Access Compliance Report

Public Rights-of-Way

(Pedestrian Signals)

Intersection ID: N/A	Main Street:	Cross Street: N/A	Location: N/A
ADA ID: A1905E19D1A2	Signal Type: Two Push Buttons-APS	Overall Compliance: No	Severity Score: BTN 1:N/A BTN 2: N/A No BTN: N/A
Codes/Mitigation Info/Possible Solution		Field Measurements/Component Compliance

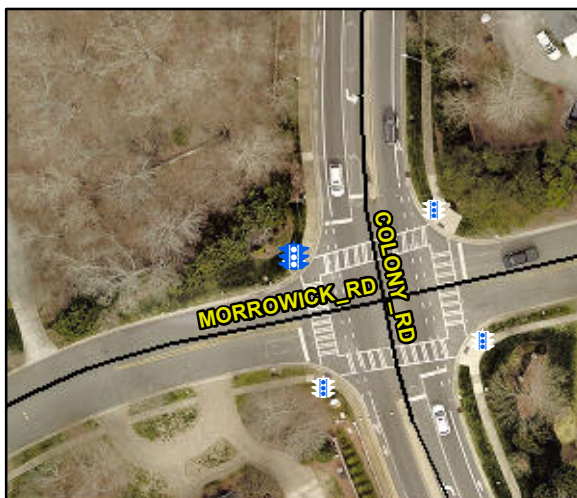
PROW/ADA: TMUTCD 4e.08, R404.2, , R406.2

Yes	B 1 Clear Xing Direction?	ClearlyMarked	Yes	B 2 Clear Xing Direction?	ClearlyMarked
	B 1 Crossing Direction	To SE		B 2 Crossing Direction	To NE
Yes	B 1 DistanceTo XWalk (in)	0.0	Yes	B 2 DistanceTo XWalk (in)	36.0
No	B 1 DistanceTo Curb (in)	80.0	Yes	B 2 DistanceTo Curb (in)	71.0
Yes	B 1 Diameter (in)	2.0	Yes	B 2 Diameter (in)	2.0

Possible Solutions: Replace Signal Push Button With APS Button on New Post.
Remove & Relocate Sign. Remove & Replace
Replace APS Button With New APS Button.
Remove and Replace Clear Space.
